Project: 226052 DFCI-BIDMC New Cancer Hospital - 1 Joslin Place - Construction
1 Joslin Place
Boston, Massachusetts 02215

RFI #0-PB-132: L4 Domestic Hot Water Heater Gas Connection Size

Reference Drawing P1.04

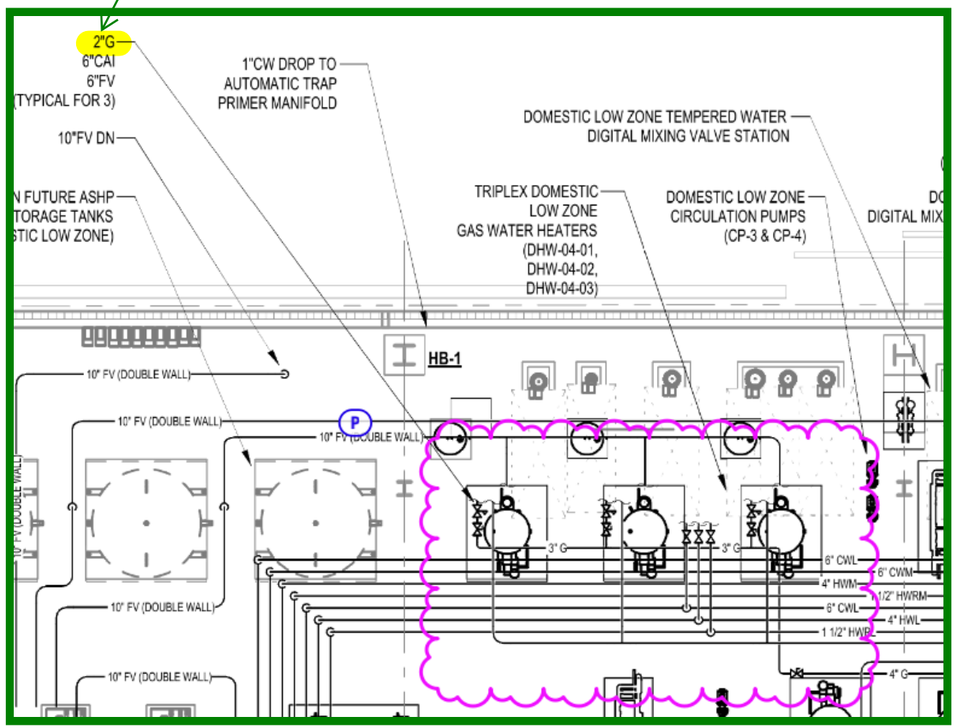
Please reference Drawing P1.04, Drawing P0.02, and the attached markup showing the gas connection to the domestic hot water heaters (DHW) on Level 4. The floor plans call for a 2 inch gas connection to the DHW whereas the schedule on Drawing P0.02 calls for a 1" gas connection. Please confirm the required gas connection size.

SCCI: Floor Plan indicates 2" gas pipe, Schedule indicates 1" gas pipe

The connection size on the schedule is the required connection size on the water heater. 2"Gas supply on P1.04 is correct. Contractor shall reduce 2"supply prior to connection at water heater to match the water heater connection size.

Reference Drawing P1.04

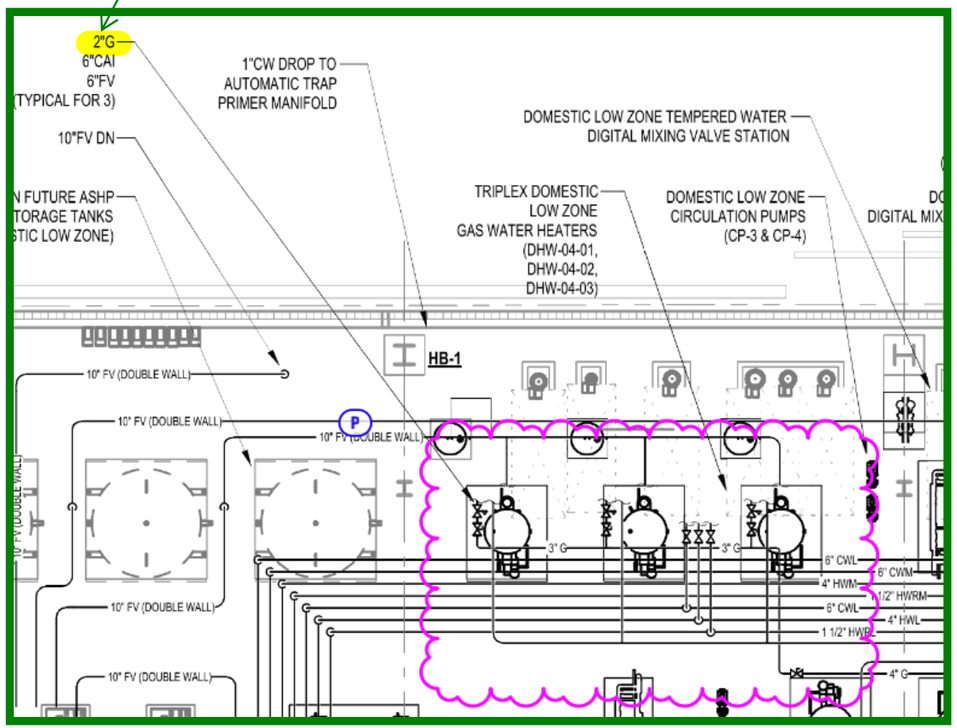
Please reference Drawing P1.04, Drawing P0.02, and the attached markup showing the gas connection to the domestic hot water heaters (DHW) on Level 4. The floor plans call for a 2 inch gas connection to the DHW whereas the schedule on Drawing P0.02 calls for a 1" gas connection. Please confirm the required gas connection size.

SCCI: Floor Plan indicates 2" gas pipe, Schedule indicates 1" gas pipe

The connection size on the schedule is the required connection size on the water heater. 2"Gas supply on P1.04 is correct. Contractor shall reduce 2"supply prior to connection at water heater to match the water heater connection size.
